Pimkie Apparels Ltd (New Building)

Plot # 327, Block # F, Tongi, Industrial Area, Dhaka
(23.52563N, 90.23479E)
6th September 2021

7 Observations: Building-2

Isometric view

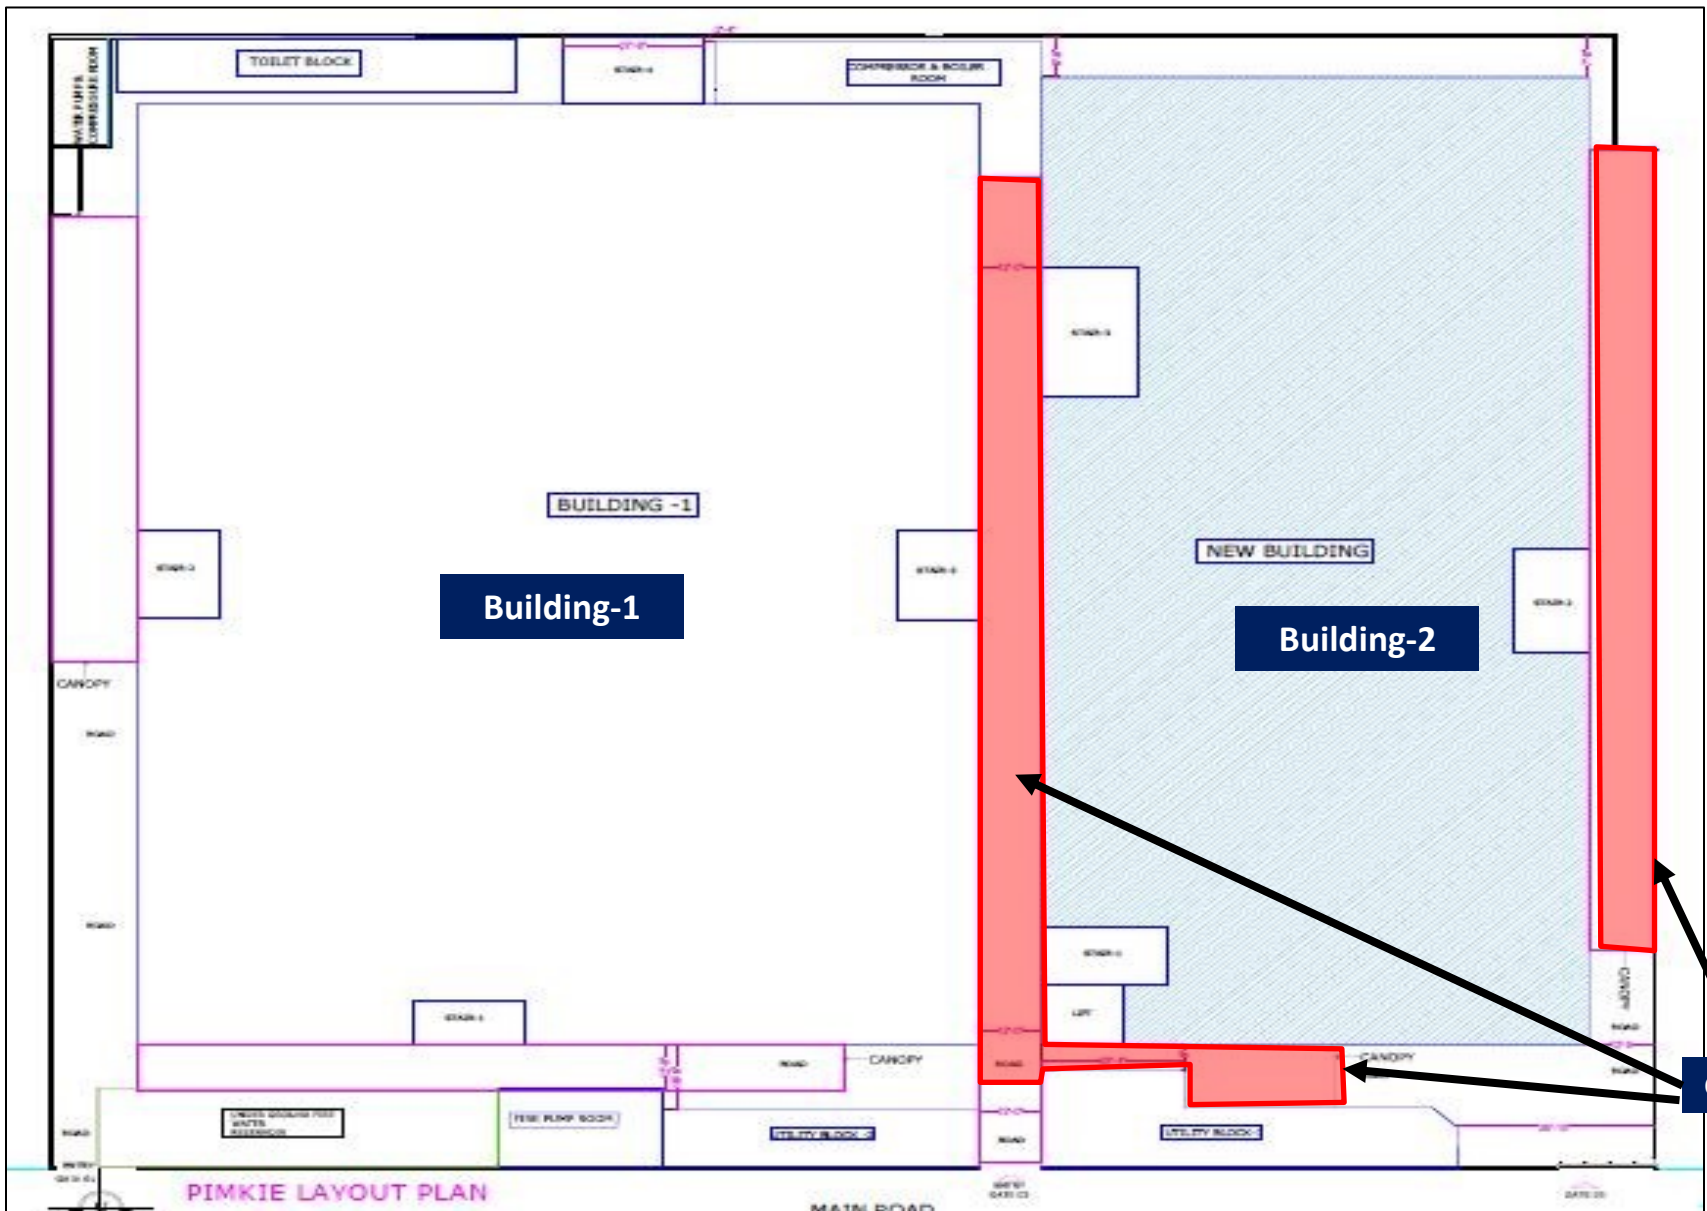
Design report needs to be prepared

As per BNBC every building or structure designed shall have its design documents prepared in accordance with the provision of Section 1.9.1. The design document shall include a design report, and a set of structural drawings, which shall be prepared in compliance with section 1.9.1.1 and section 1.9.1.2 as per BNBC. During the inspection, only as-built drawing was available however no design report was available which is required to be prepared in compliance with section 1.9.1 (part-6, BNBC).

Item No.	Observation	Recommended Action Plan	Recommended Timeline
01	Design report needs to be prepared. (Building-2)	Building engineer to prepare the Design Report for the full structure, in compliance with section 1.9.1 as per BNBC.	6-weeks
02	Design report needs to be prepared. (Building-2)	Complete implementation of any remedial works deemed necessary by the Design Report.	6-months
03	Undocumented canopies structurally connected with Building-2	Building Engineer is required to check the connection adequacy of the canopies.	6-weeks
04	Undocumented canopies structurally connected with Building-2	Building engineer to prepare the Design Report for the canopy, in compliance with section 1.9.1 as per BNBC.	6-weeks

Canopies connected with Building-2

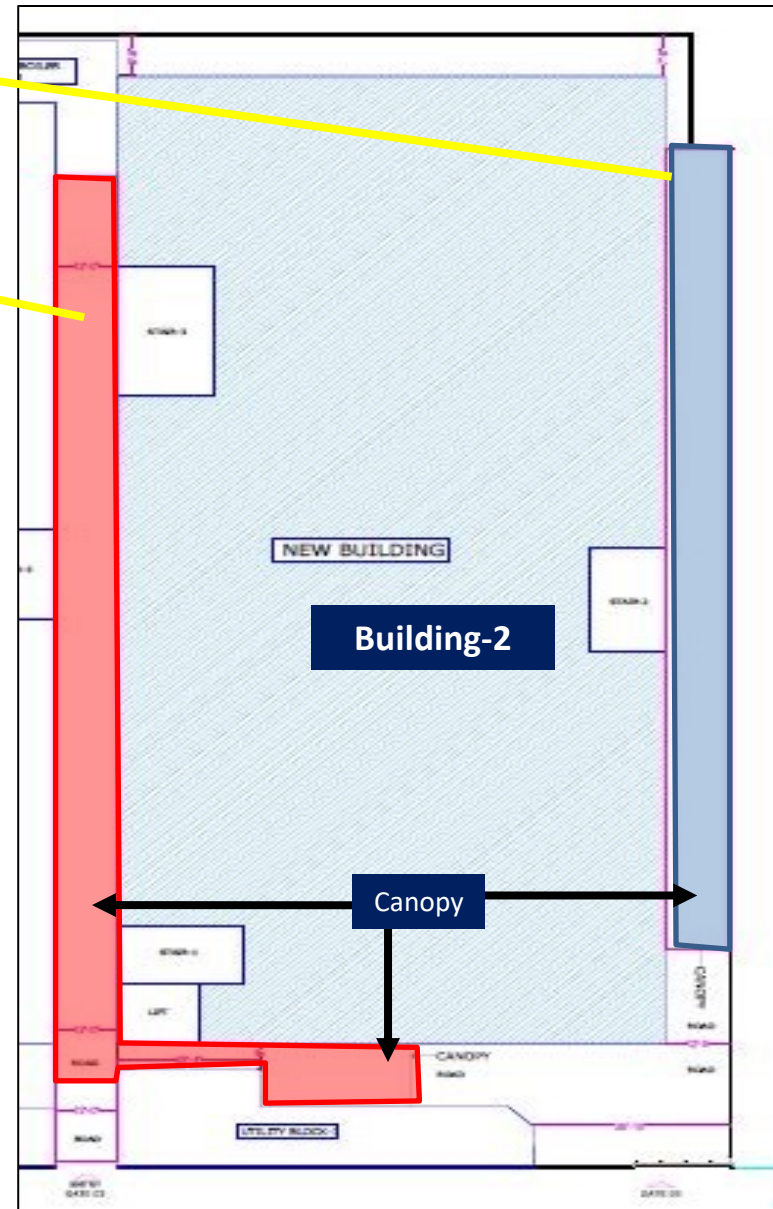
Undocumented canopies structurally connected with Building-2

There are canopies in three sides of Building-2 (east, west and north direction) which are structurally connected with brick wall where load paths are not clear. Factory engineer is required the check the connection adequacy and stability of these canopies. And also prepare design document in compliance with section 1.9.1 (part-6, BNBC 2006).

Item No.	Observation	Recommended Action Plan	Recommended Timeline
05	Undocumented canopies structurally connected with Building-2	Complete implementation of any remedial works deemed necessary by the Design Report.	6-months
